Upper-Intermediate Mass for the ETM Controls Prototype Quad Pendulum Suspension

PRODUCT DESIGN SPECIFICATION

ETM CONTROLS PROTOTYPE U-I MASS

QUESTIONS FOR DESIGN MEETING 013, MONDAY JUNE 28TH 2004

1) Reduce the 'n1' (half separation of the break-offs in y-dir) from 70mm to 50mm:

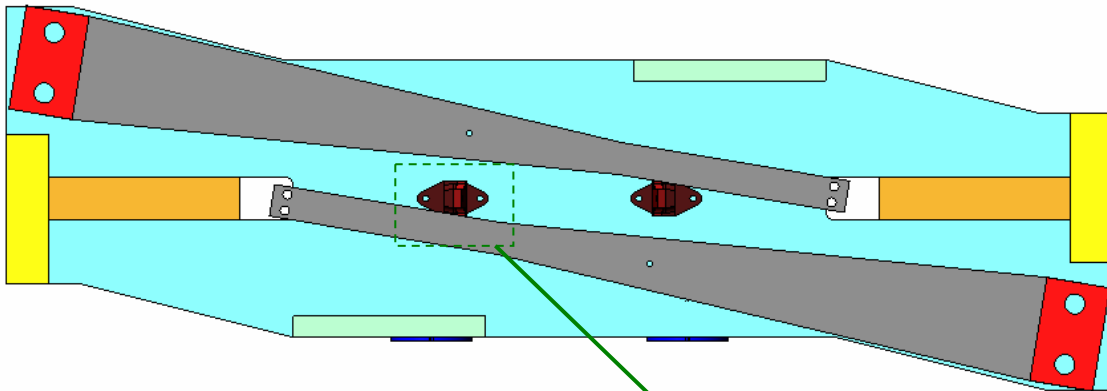
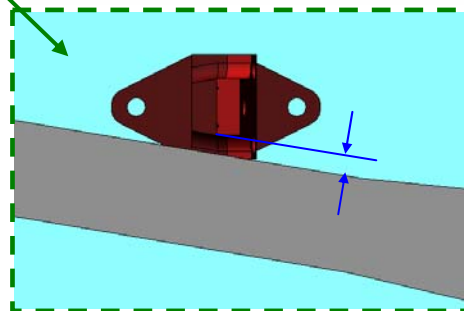
Problem: Limited space on U-I Mass bottom plate causes interference between blades and the suspended mass wire clamps.

Calum recommends that we need to have 2-3mm between the blade and the wire clamp to allow for alignment and adjustment.

Distance between blade and wire-clamp: 2.96mm

- i. Can this be done without affecting the suspension performance?

>>>> I need to know whether it would be possible to reduce the n1 value
>>>> on the Quad to 50mm from 70mm. The problem is that with the current
>>>> layout the blade will interfere with the clamp. Calum thought that
>>>> reducing n1 to 50mm shouldn't affect suspension performance greatly
>>>> considering that the n0 is 200mm.

>>> Changing n1 to 0.05 and also l1 to 0.313 (from 0.304) to keep
>>> overall length of quad the same does have a slight adverse affect on
>>> the yaw. The frequencies are Ok but coupling to the highest mode

>>> (at around 3.1 Hz) gets worse - typically the Q doubles. Although
>>> this isnt directly affecting the settling time, which is dominated
>>> by the lowest mode, I am musing about whether there could be any
>>> problems (for example applying Ken's latest ideas about damping as
>>> combination of active for the low freqs and ECD for the higher
>>> ones). I want to muse a bit longer. Will get back to you soon.

>> I wanted to ask if making n1 0.06 is enough of a change to fit in
>> wire clamps - it gives a less significant change to the yaw
>> behaviour. I am still musing on whether the 0.05 is acceptable but
>> thought i would ask anyway.

> As we are looking at altering the blade to having a narrower tip it is
> not necessary to move the break-off as far from the 0.07m as I
> proposed. I have checked the model - moving the wire clamp to 0.06
> from the centre of mass - and this seems to be okay.

That's good! Let's settle for n1 = 0.06. I'll check what l1 has to be to
keep overall length same.

- Use a narrow blade design with #8-32 holes along the length of the blade.
- Reduce n1 to 60mm.

2) Angle blades further. Diagram shows increase from 9.5degrees to 12degrees:

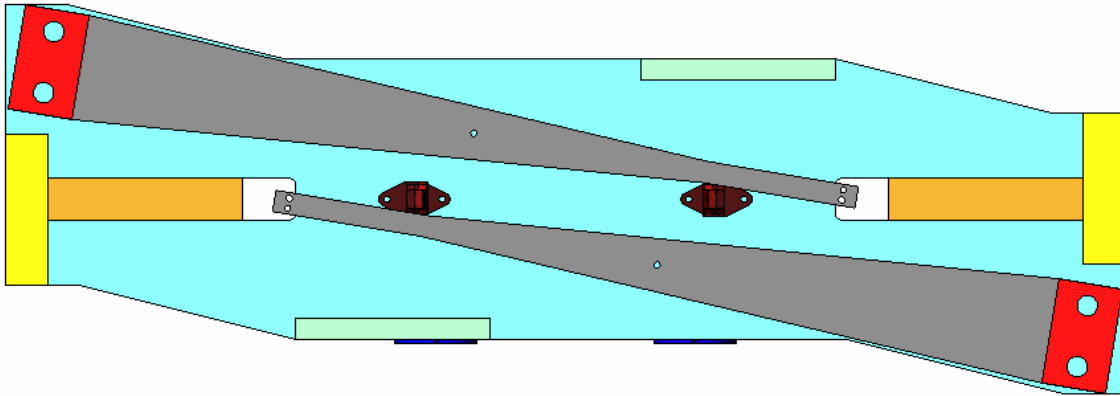
Distance between blade and wire-clamp: 2.56 mm

NOTE: Blades 11degrees gave a distance between the blade and clamp of 1.42mm

- i. Off-axis Moments (Lxy, Lyx, highlighted in **RED**) increase such that they are higher than Moments in the Y plane (Lyy).
- ii. Norna – I expect that this is not good?!

3) Reduce blade width at tip to 10mm:

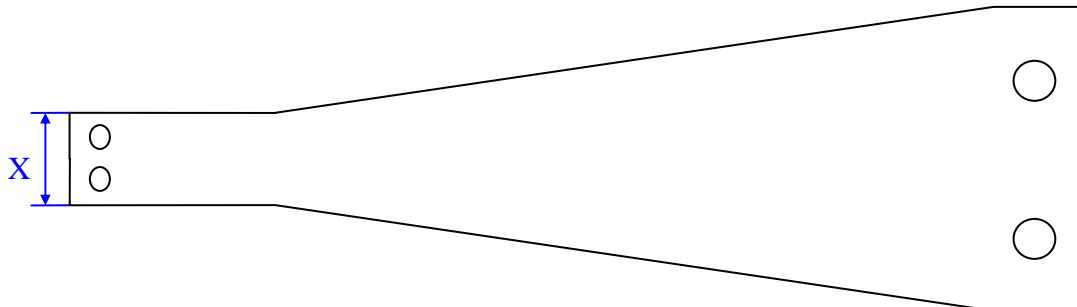
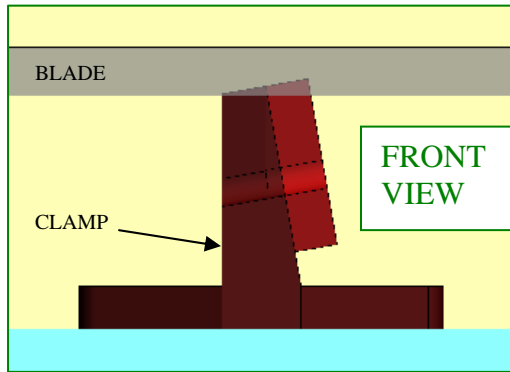
Distance between blade and wire-clamp: 2.16 mm

```
>>>Would it be okay to move to a 10mm width at the thin end instead of
>>>15mm?
```

```
>>>I know that in the past that you generally preferred not going below
>>>12mm however I imagine this may have been in the situation where
>>>there was a neck?!
```

```
>>To answer your question about the blades. It sounds like the design
>>you are proposing has a trapezoidal shape. Is this correct? I suppose
>>the issue then is how much material there is around the holes drilled
>>for the clamp. If the holes are one behind the other then 10 mm width
>>is probably OK. Of course the spring constant of the blade will be
>>slightly
>> different with this revised shape but it is hard to say how much it
```

However, I want to change these to bolts #4-40 bolts (2.8mm DIA) and a width of X=10mm.

1. The bolts are strong enough for the loads involved
2. The bolt heads do not interfere. (I would think that the holes must be drilled fairly close to the edge for this not to be a problem, unless you envisage a special clamp design).

NOTE: #4-40 Socket Head bolts have a maximum head diameter of 0.183in (4.65mm) therefore two can fit laterally on a 10mm blade tip.

- i. Is this going to affect the blade performance? Shouldn't be a problem – Comments from DM013.
- ii. Can we use #4-40 bolts for the blade wire clamp? Probably be okay (original BWC concepts has #2-56 but deemed fiddly to work with) but maybe we could use #8-32 but position the holes along the blade.

4) Raise Blades to Avoid Interference:

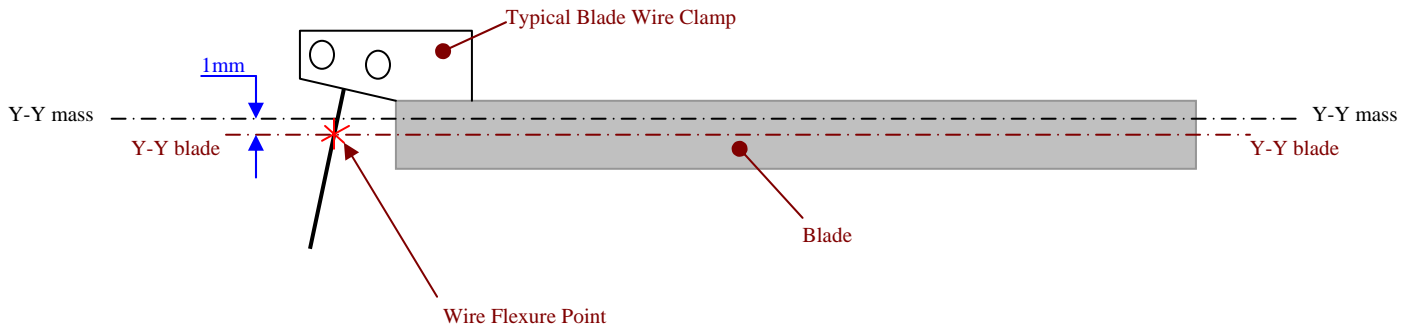
The blade collides with the clamp in the Y-Z plane by around 1.5mm. Could we raise the height of the blade to avoid this interference (adjusting for the break-off height via the blade wire clamp)?

NOTE: The central axis of the plane originally was set at 1mm below the centre of gravity for the U-I mass.

- i. As the blade is not guaranteed to be perfectly flat under load, there is still a possibility that the blade will hit the clamp when loaded.
- ii. Moving the blade from the default position, and compensating with the clamp, will cause a cross coupling which will in-turn affect the suspension performance.

It is best that a combination of solutions proposed in 1 and 3 are adopted for the design.
